SUBJECT: PLANS AND PROPOSAL ADDENDUMS

PROJECT: F 2023(485)

CONTROL: 0047-14-087

PROPOSAL ADDENDUMS

**SW3P SITE MAP
PLANTER BED B1**

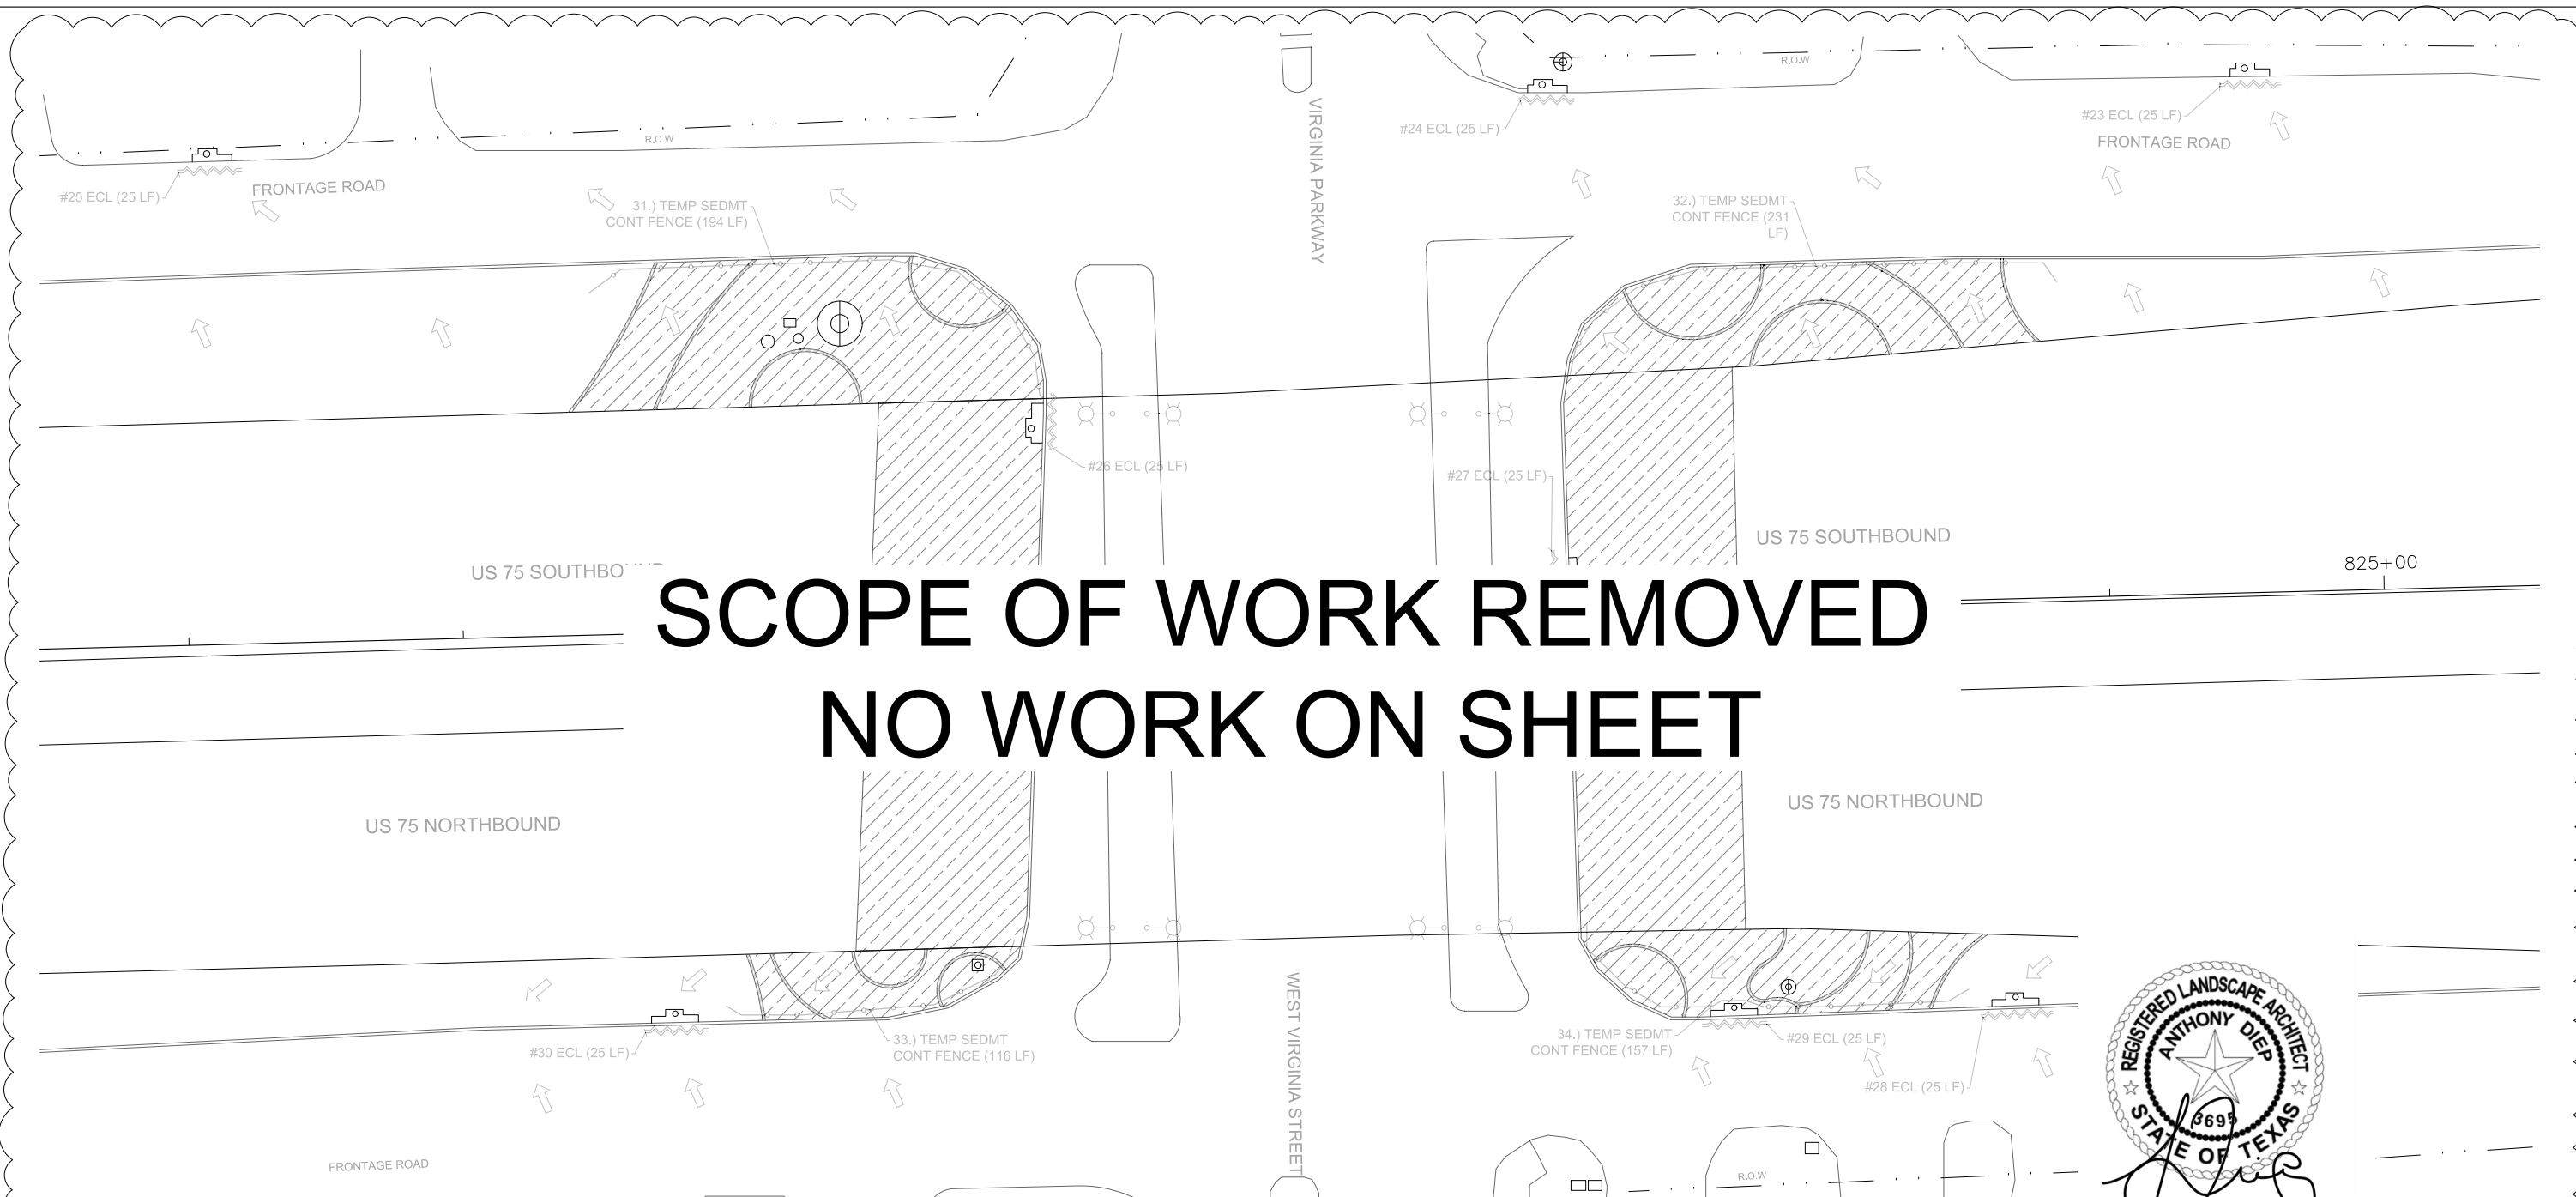
SCOPE OF WORK REMOVED NO WORK ON SHEET

LANDSCAPE LAYOUT PLANTER BED B1

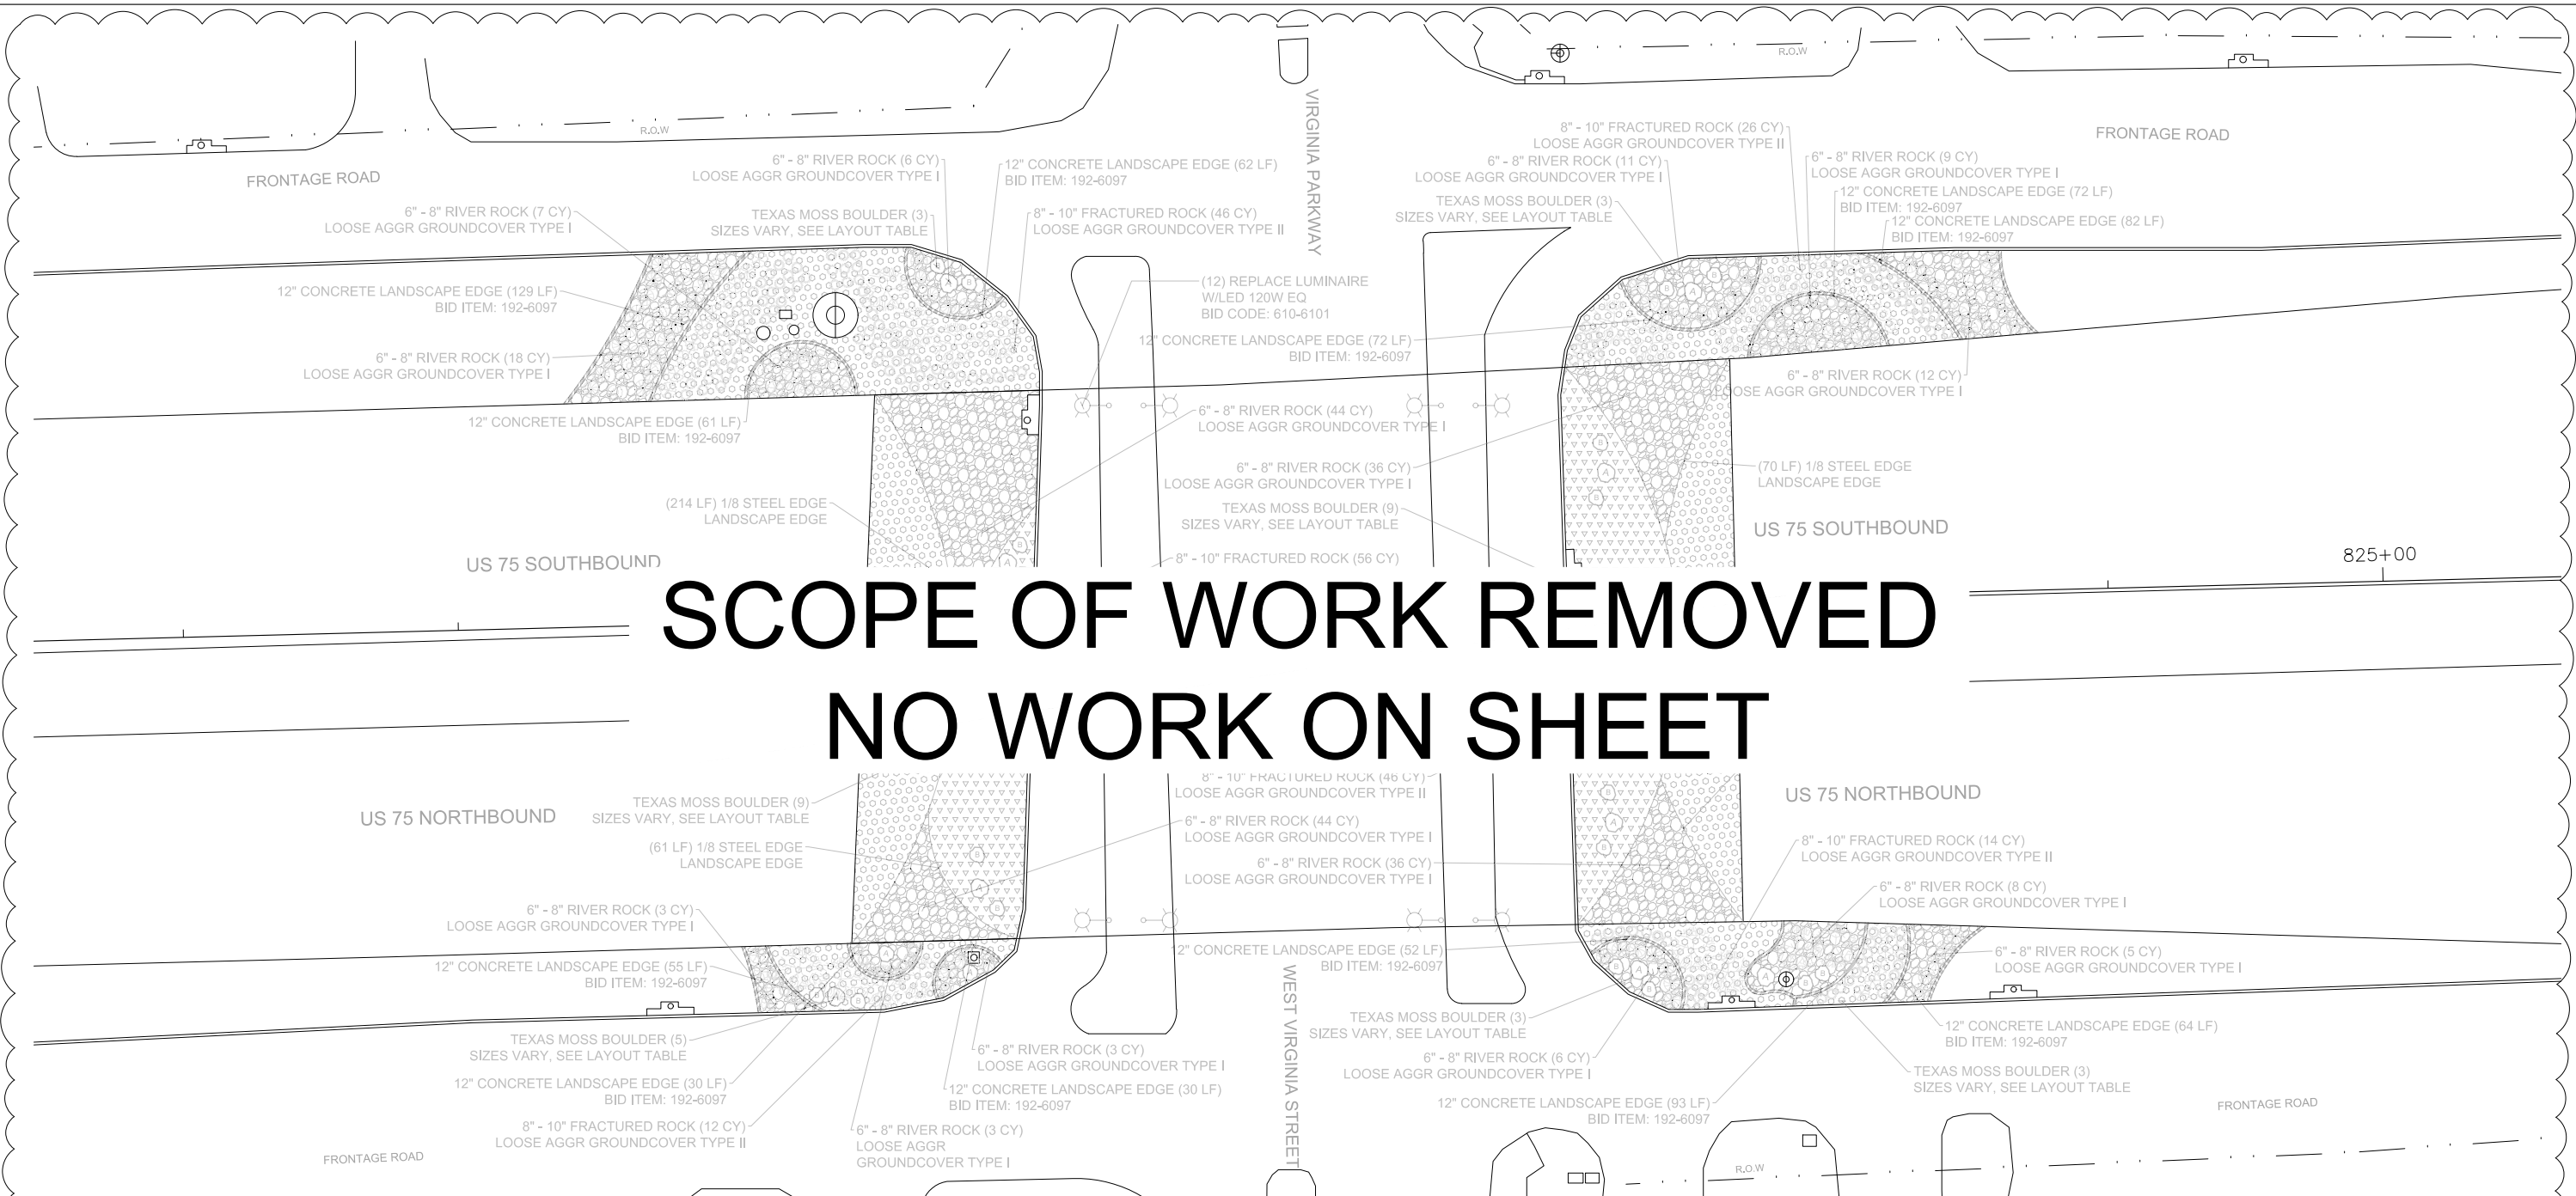
SCOPE OF WORK REMOVED NO WORK ON SHEET

**PLANTING PLAN
 PLANTER BED B1**

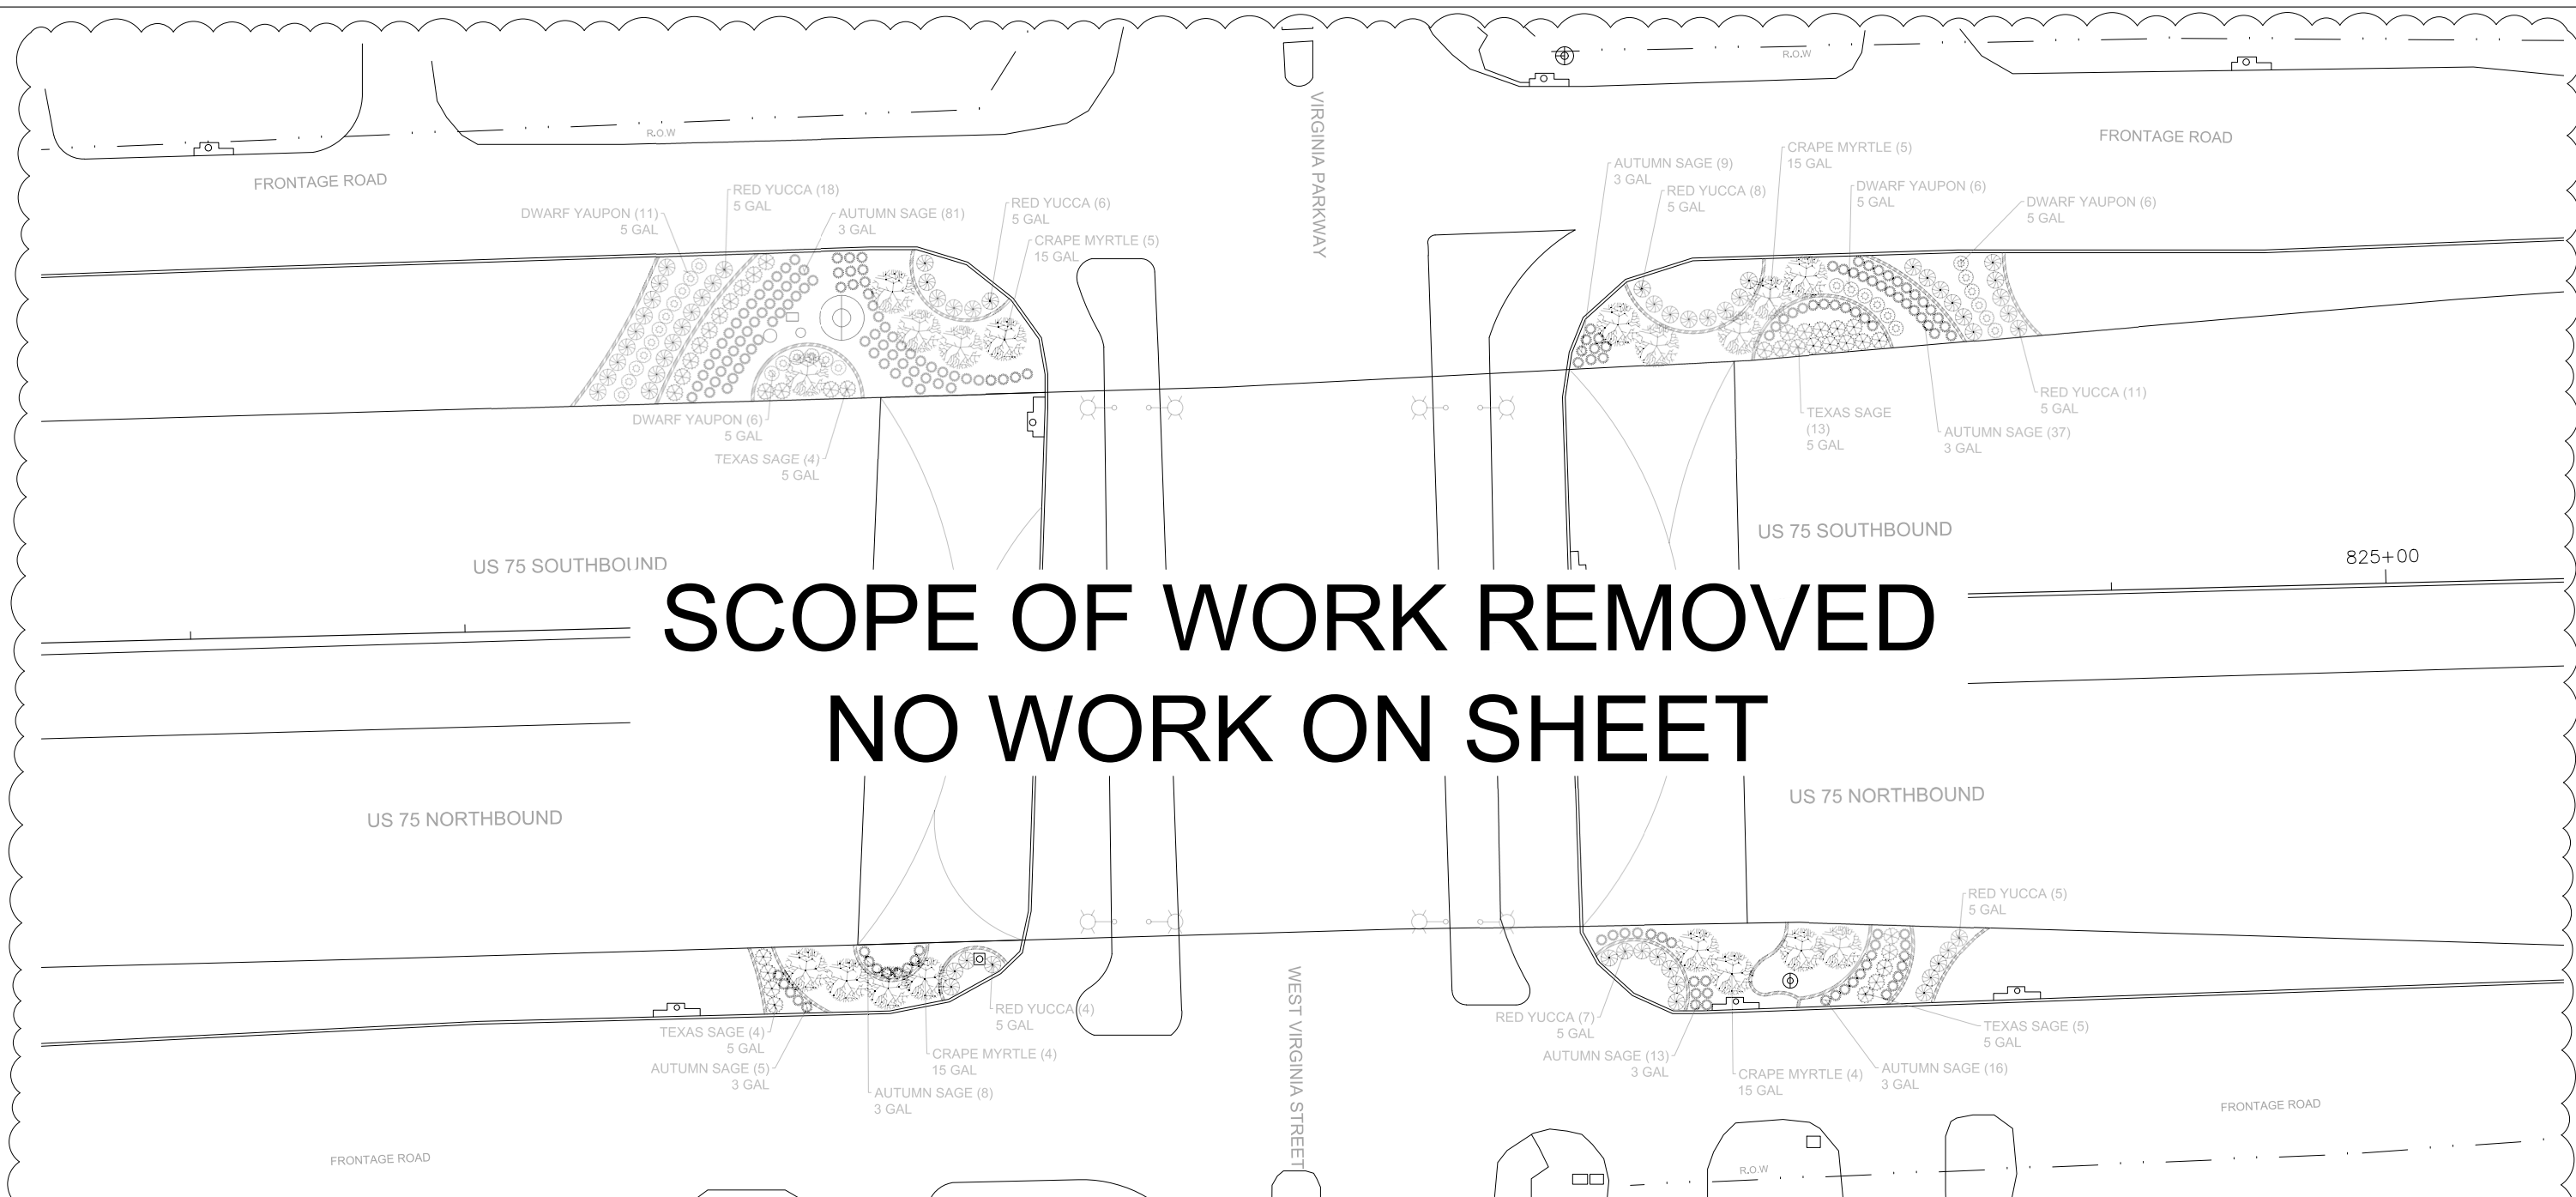
SCOPE OF WORK REMOVED NO WORK ON SHEET
